# **INFORMATION HANDOUT**

**For Contract No. 07-287604**

**At LA-101-PM 8.5/9.4**

Summary of Foundation Recommendation Reports

**SITE PLAN**  
L-1

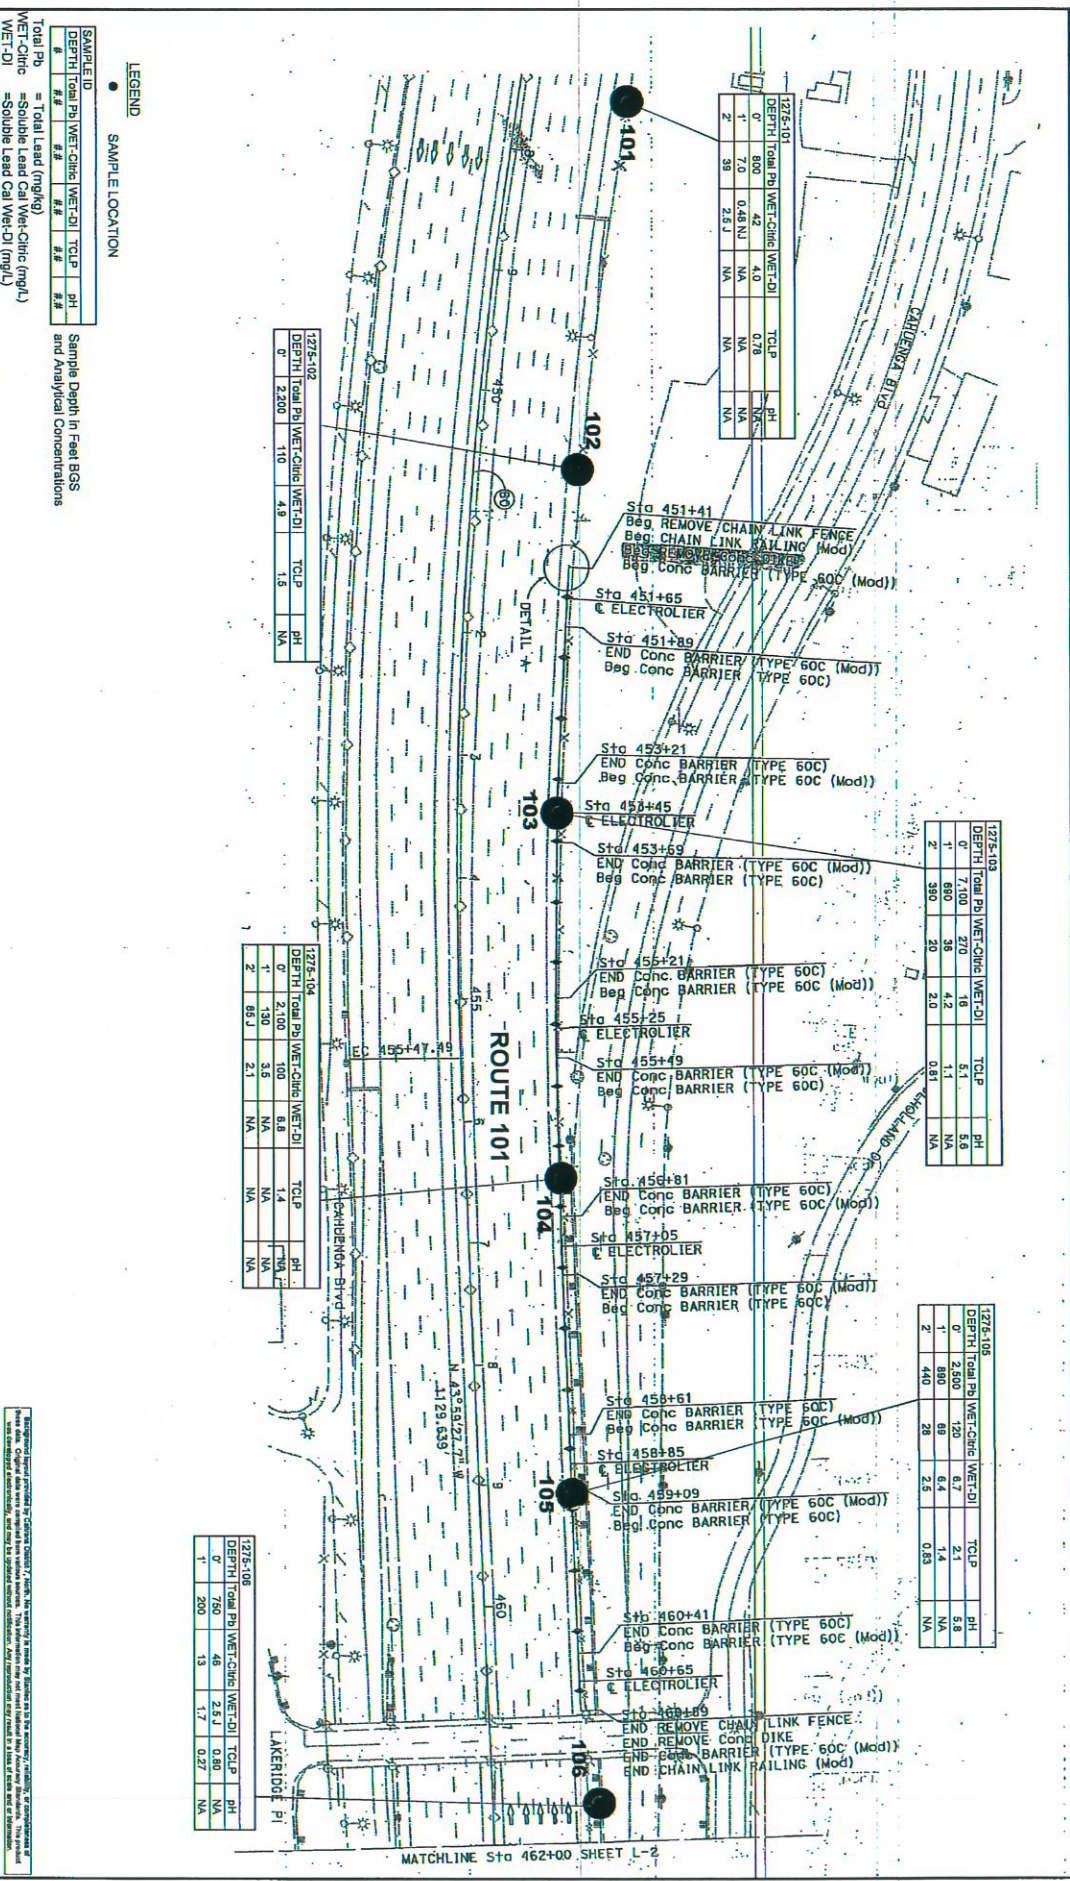
Please review the note below that we would like to put in our plans to address the ADL soil excavation. Please review and let us know if these notes cover your intended ADL recommendation. I would also like you to review the station of Type Z-3 limits as you mentioned in your recommendation. Looks like, Station 471+0 to 473+60 falls between Station 465+50 to 480+10. Please check the station "480+10".

The 480+10 is a typo, should have been 468+10. Please, see Figure 3, hatched area of the ADL report, that was provided recently.
